SERVICE BULLETIN

ENGINE INDICATING - ENGINE - EXHAUST GAS TEMPERATURE (EGT) INDICATING SYSTEM
REPLACEMENT OF EGT LOOP CLAMP BRACKETS - CATEGORY CODE 5 - MOD.ENG-77-0003

V2500-ENG-77-0003

Replacement of Exhaust Gas Temperature (EGT) Indicating System Loop Clamp Brackets
Fig.1 (Sheet 1 of 3)

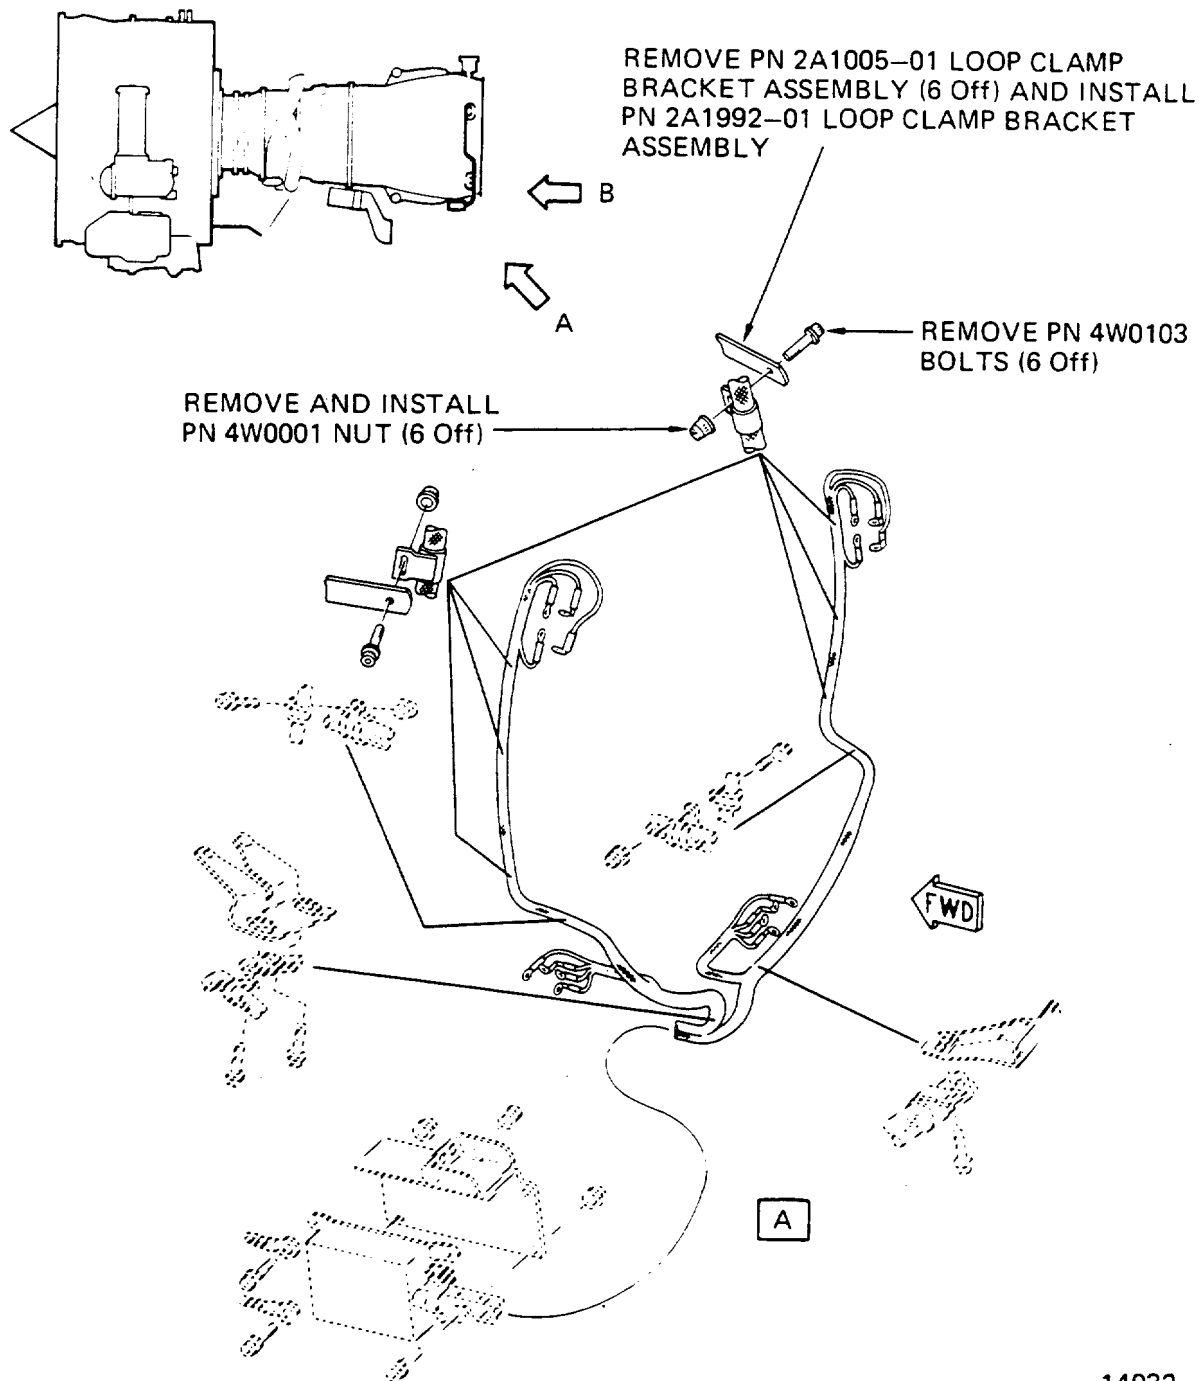
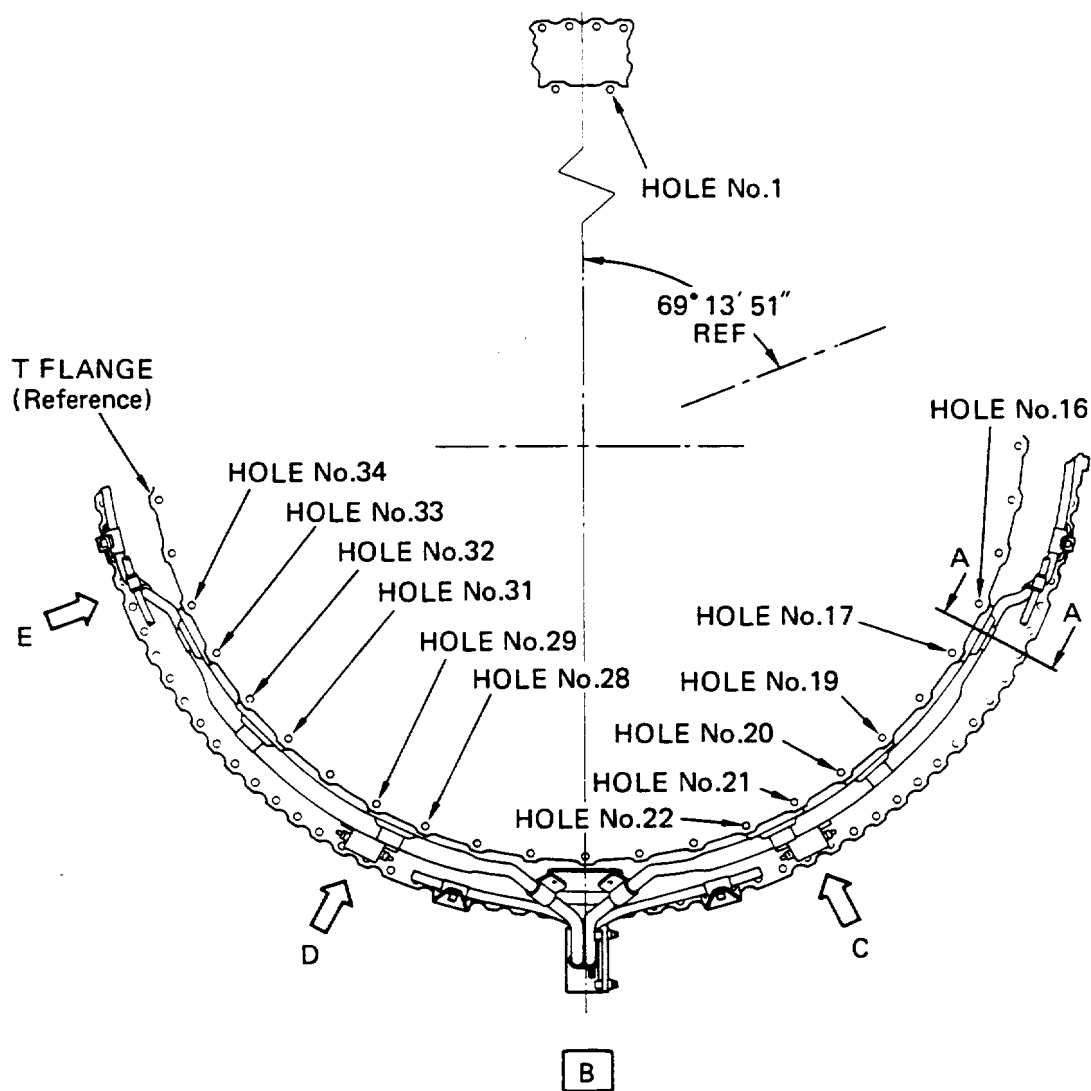
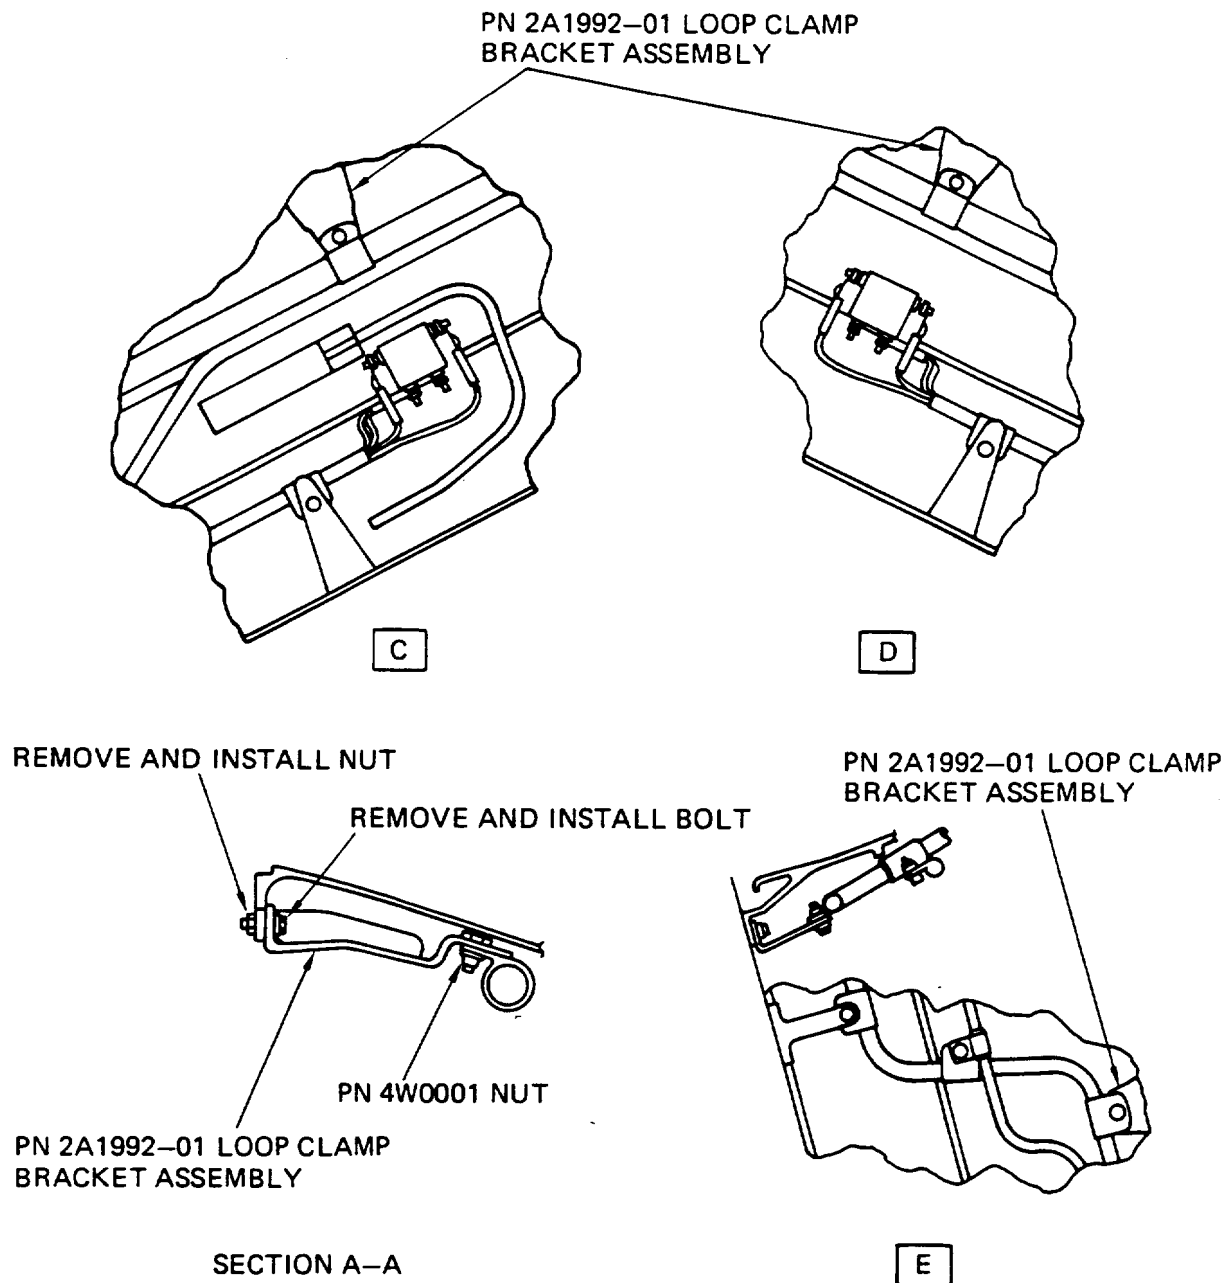
There is contact between the EGT Bracket, Loop Clamp, and Harness at six locations.

Contact causes distress of the C-Duct Heat Shielding and can cause fretting of the EGT Harness Bundle.

Provide a new design for the EGT Harness Bracket (installed at six locations) which will permit the EGT Harness and Loop Clamps to fit closer to the Engine Case.

- (1) Contact between the EGT Bracket, Loop Clamp and Harness is removed at six locations.

(a) This is done by providing a new EGT Harness Bracket and Loop Clamps.

- (1) Remove the Nuts and Bolts which hold the Loop Clamps to the Loop Clamp Brackets. Retain the Nuts and Bolts. Refer to Figure 1.
- (2) Remove the Nuts and Bolts which hold the Loop Clamp Brackets to the T Flange and discard the Nuts and Bolts. Refer to Figure 1.

- (b) Put the 2A1992-01 Loop Clamp Bracket Assembly at the location of holes 16 and 17. Refer to Figure 1.
 - (c) Install the Nuts and Bolts, through the holes in the Flange and Bracket Assembly, and tighten them with your hand.

- (d) Torque the Nuts to 100 to 140 lbfin (11,30 to 15,82 Nm), by the approved procedure in Reference (1), Chapter/Section 70-41-00, Torque Tightening Technique.

- (e) Do steps (a) through (d) again until all the Brackets are installed (at locations of holes 19 and 20 and 22, 28 and 29, 31 and 32, and 33 and 34).

- (h) Install the 4W0001 Nut. Refer to Figure 1.
 - (i) Torque the Nut to 36 to 45 lbfin (4,07 to 5,08 Nm) by the approved procedure in Reference (2), Chapter/Section 70-41-00, Torque Tightening Technique.
